BID CLARIFICATION No. 2

Re: Bedford UFSD
Phase 2 – Bond Improvements at
Fox Lane High School, Fox Lane Middle
School, Administration Building
BBS File No. 23-131a-c

1. 23-131a, b, & c Construction Implementation Plans (CIPS)

Site Plan – Contractor Access and Temporary Facilities

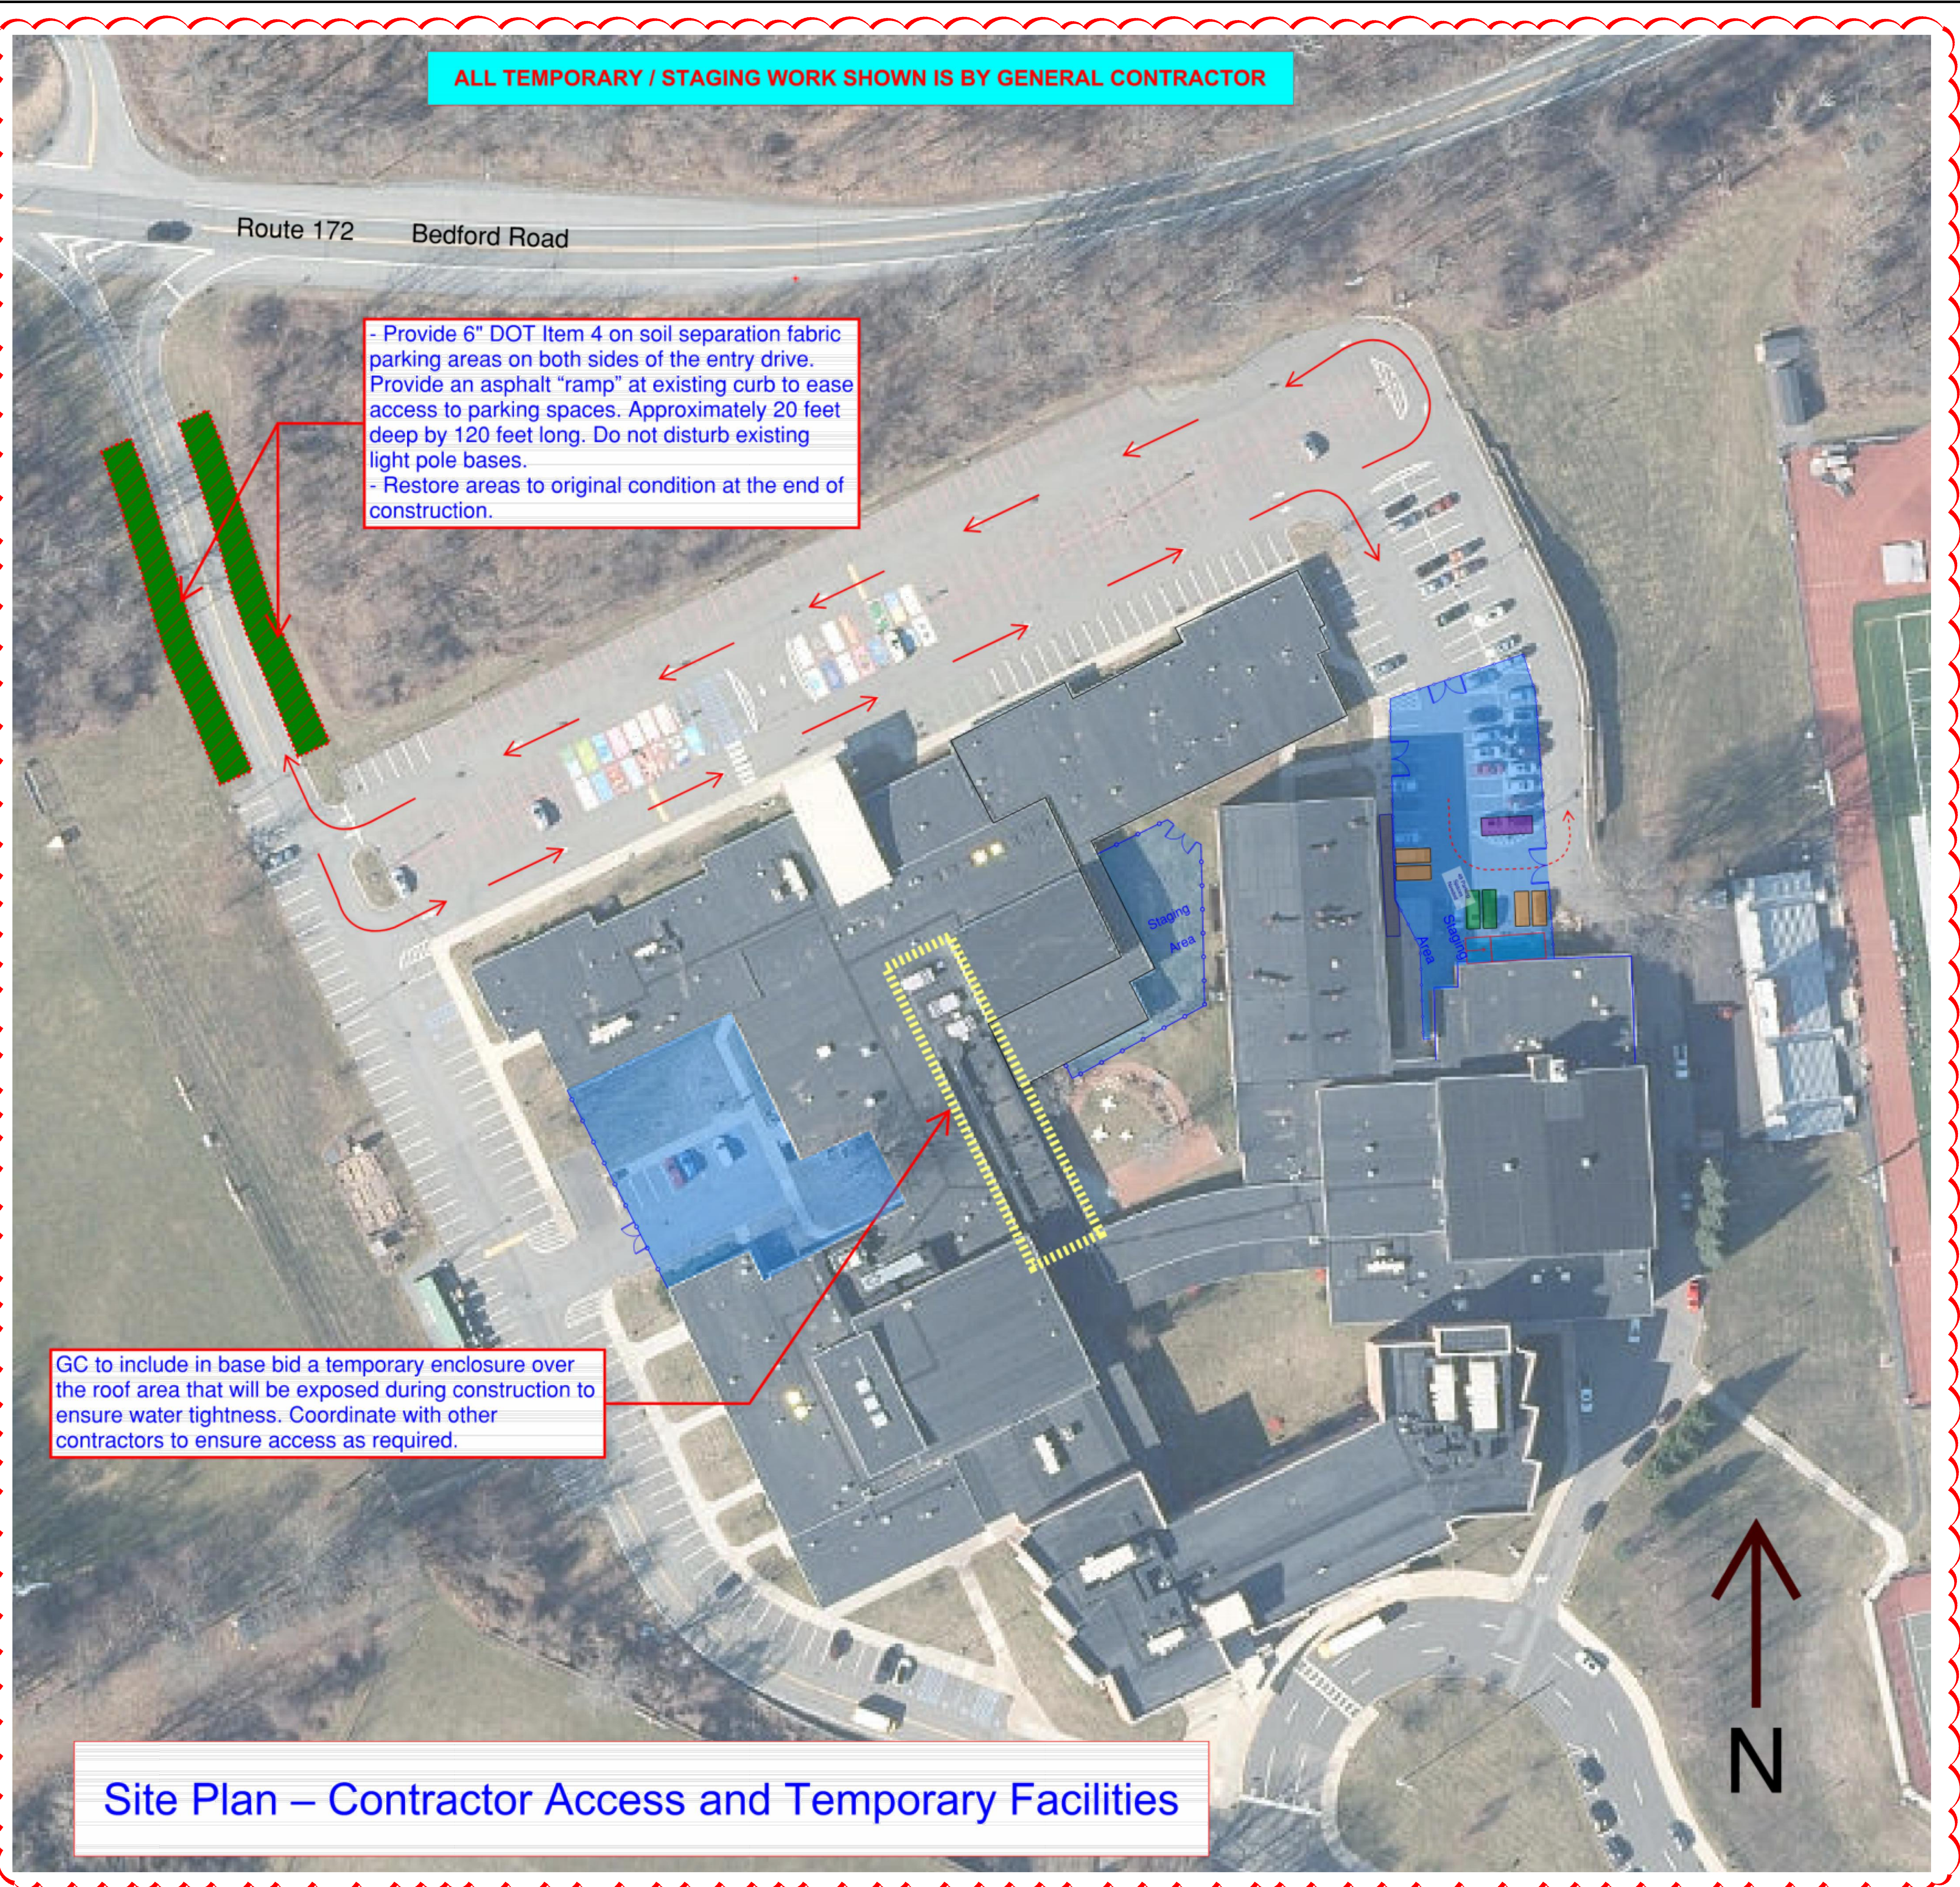
- Provide 6" DOT Item 4 on soil separation fabric parking areas on both sides of the entry drive. Provide an asphalt "ramp" at existing curb to ease access to parking spaces. Approximately 20 feet deep by 120 feet long. Do not disturb existing light pole bases.
- Restore areas to original condition at the end of construction.

GC to include in base bid a temporary enclosure over the roof area that will be exposed during construction to ensure water tightness. Coordinate with other contractors to ensure access as required.

CIP0.02

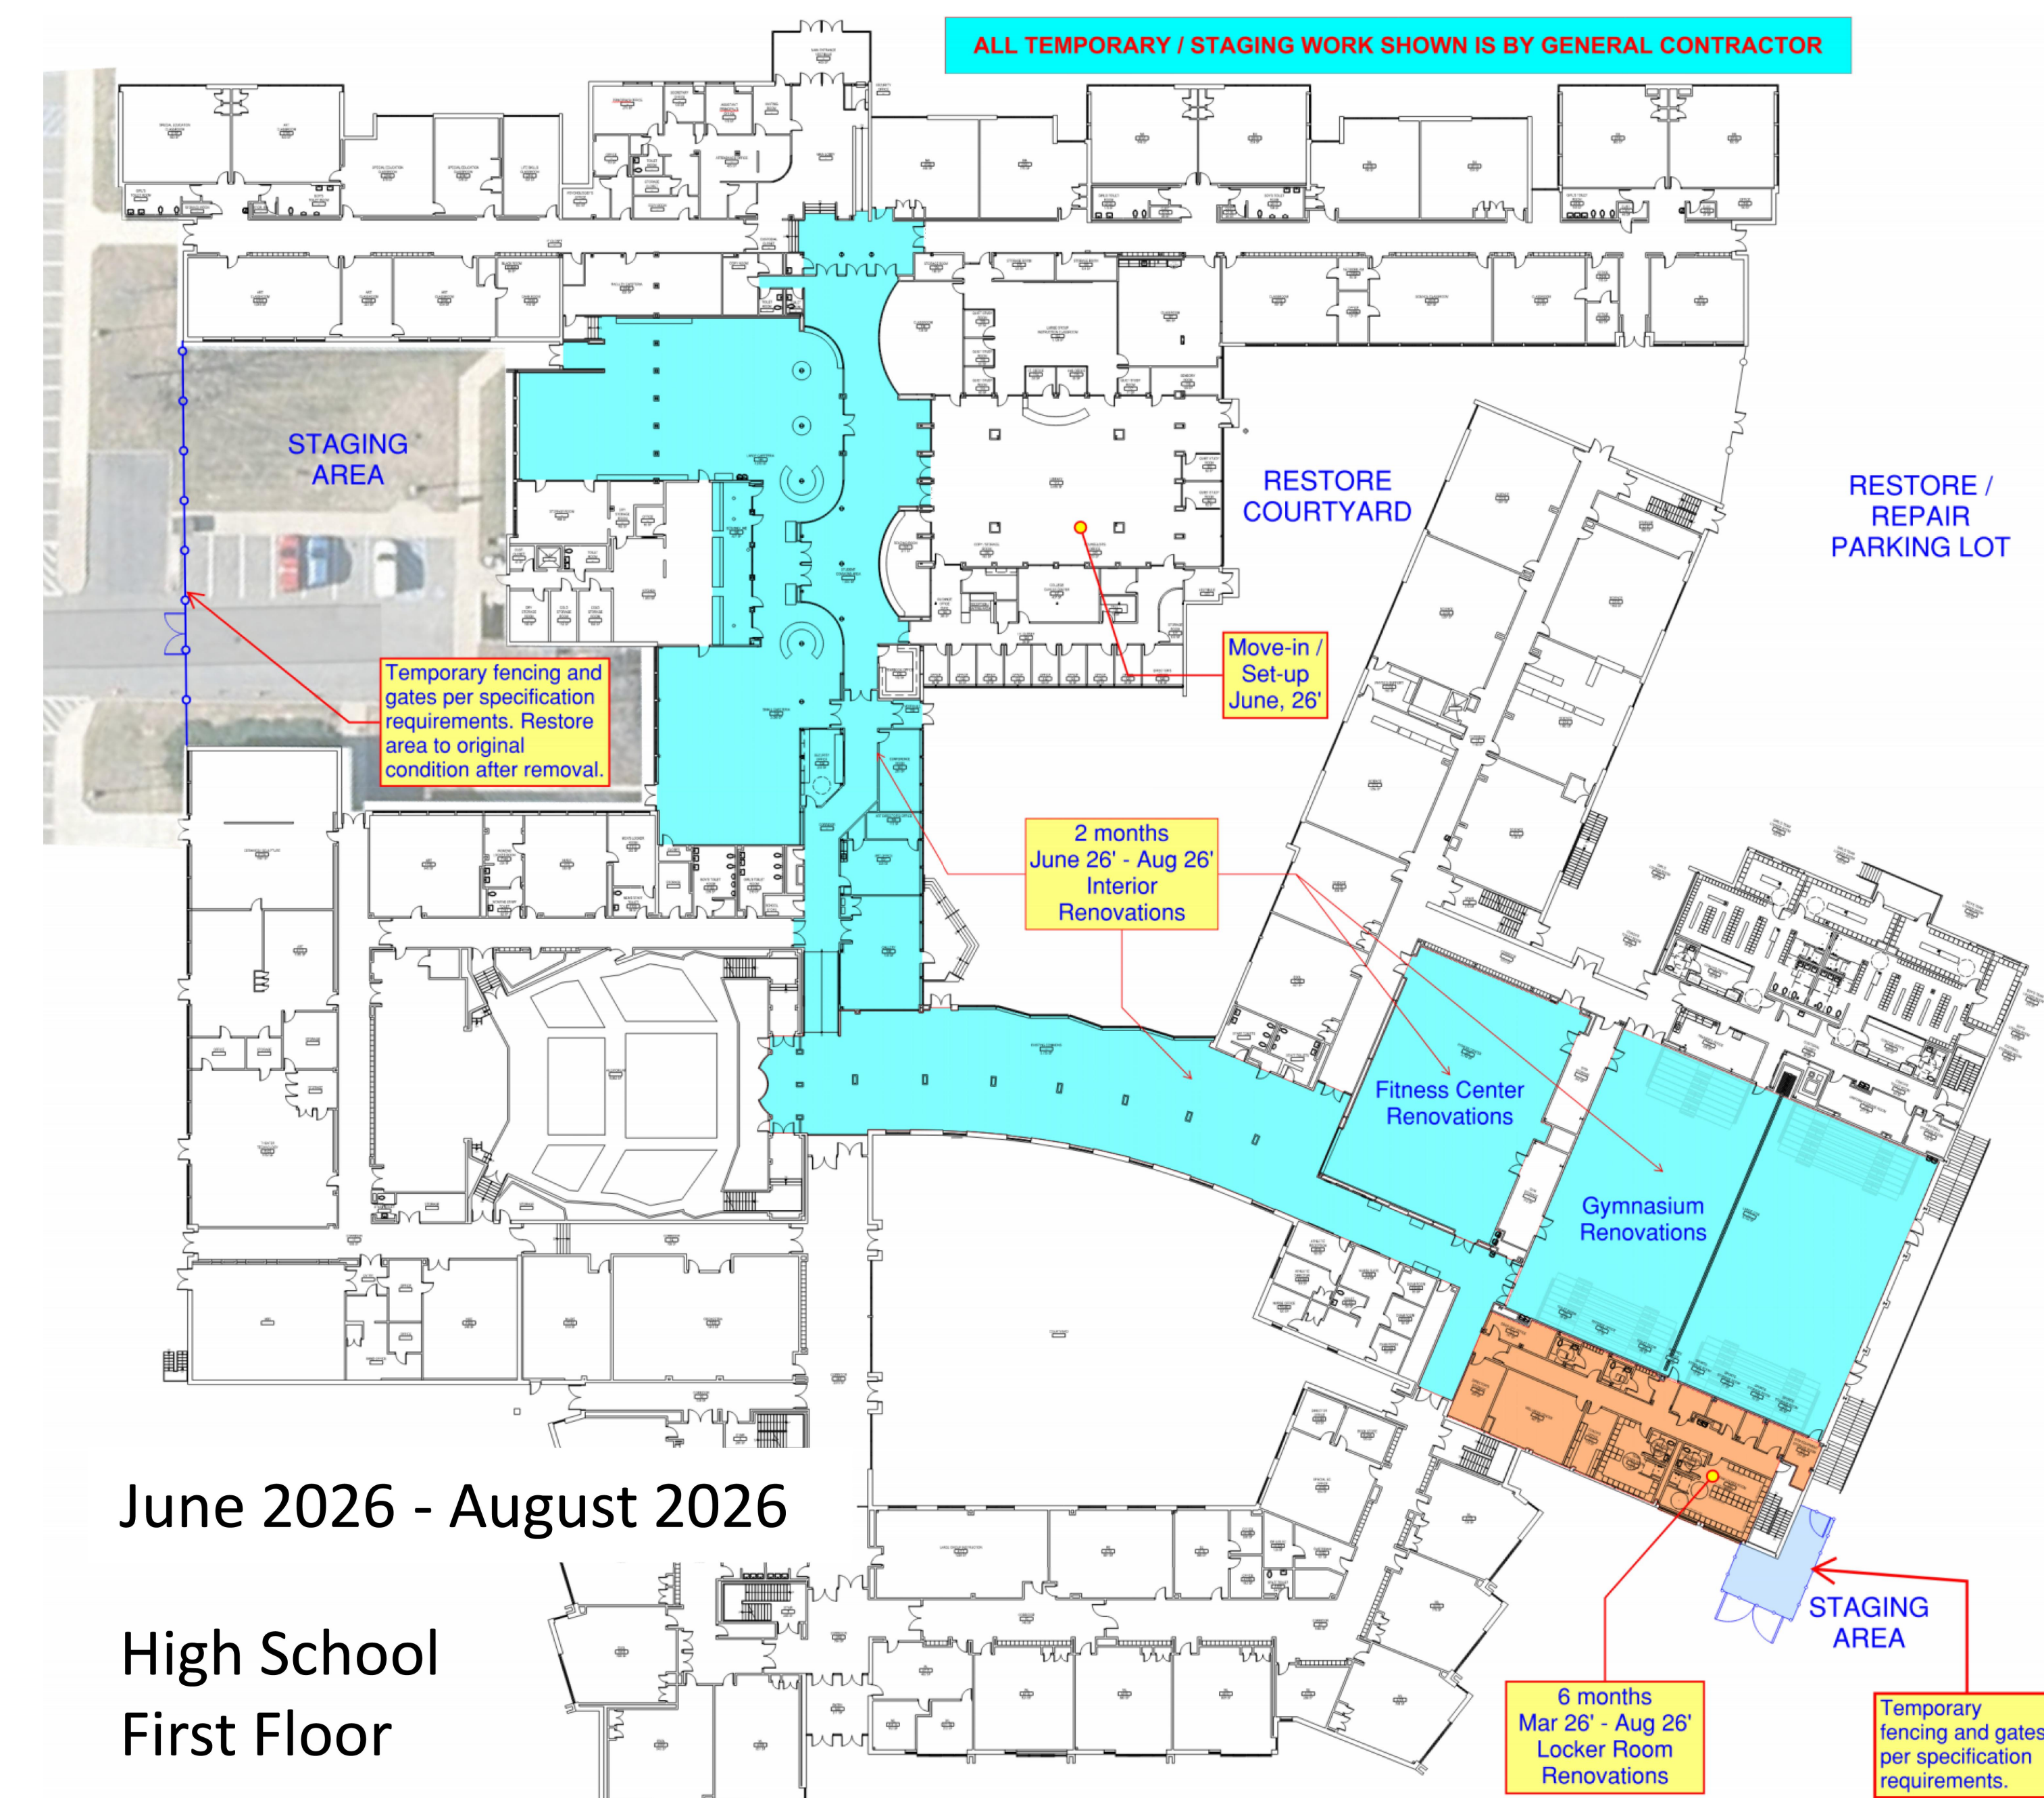
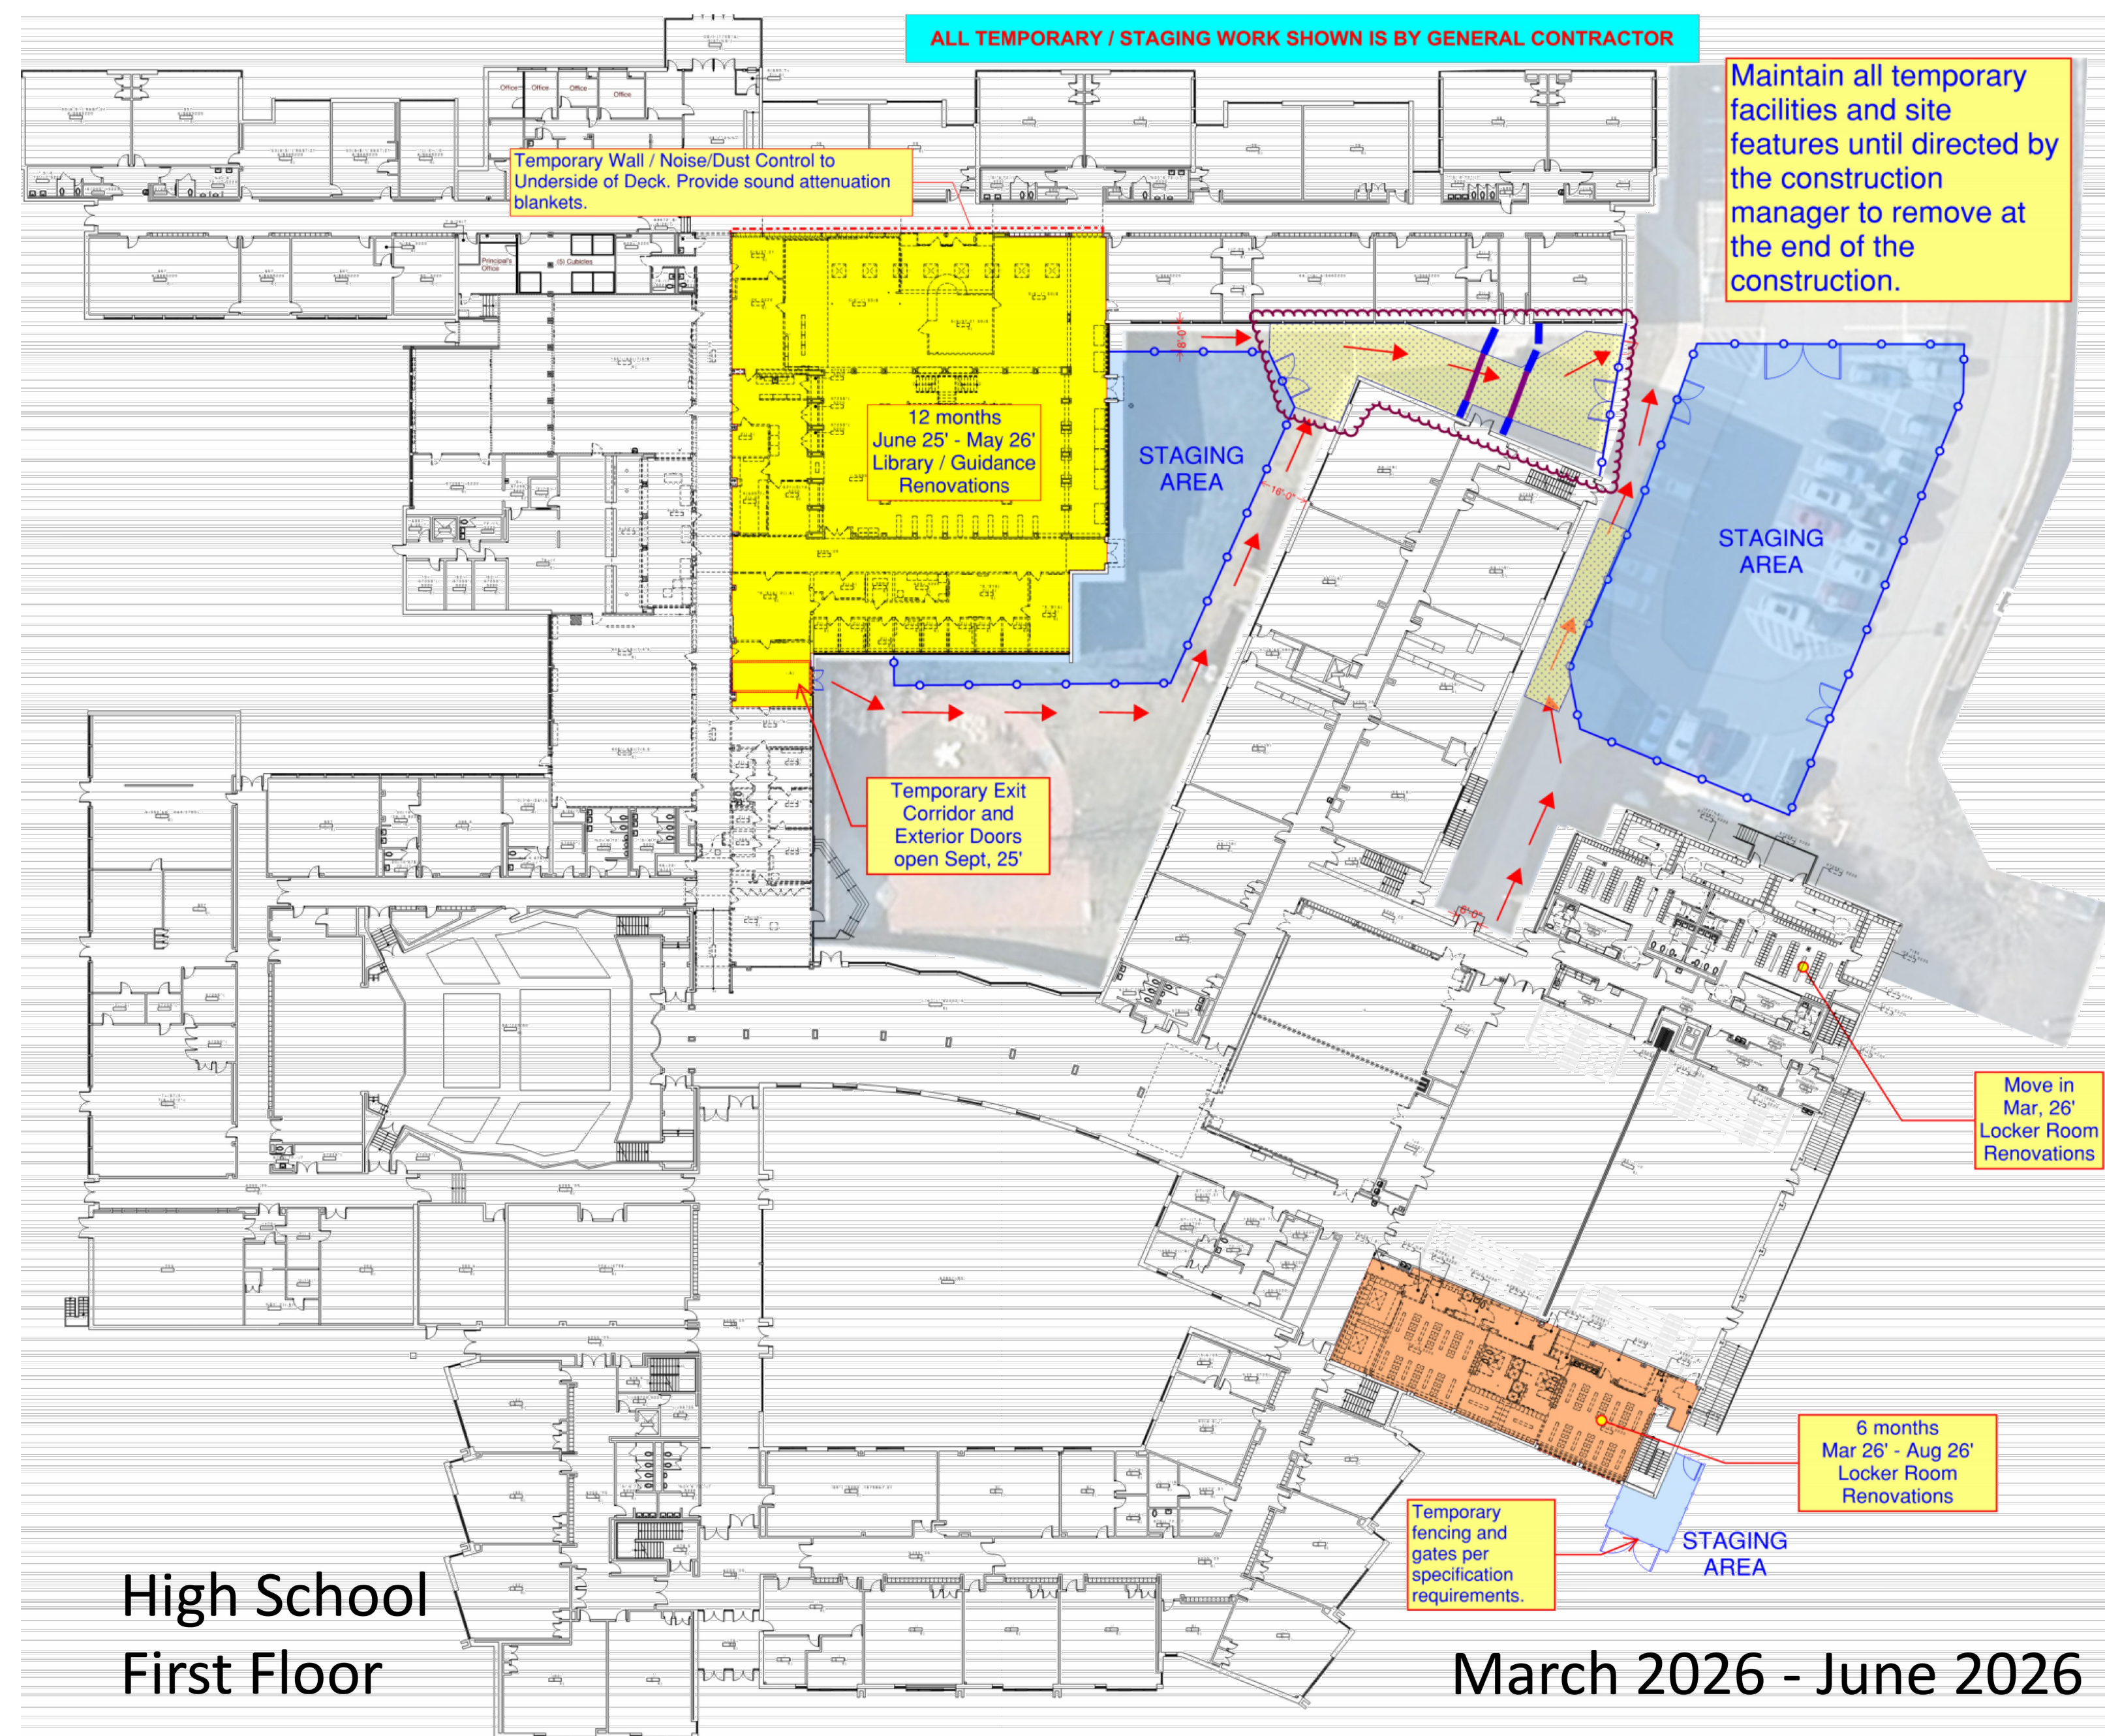
- a. The Construction Implementation Plans (CIPS) included in this clarification shall supercede the previously issued documents and all scope of work shown shall be included as part of the general contractor's base bid.
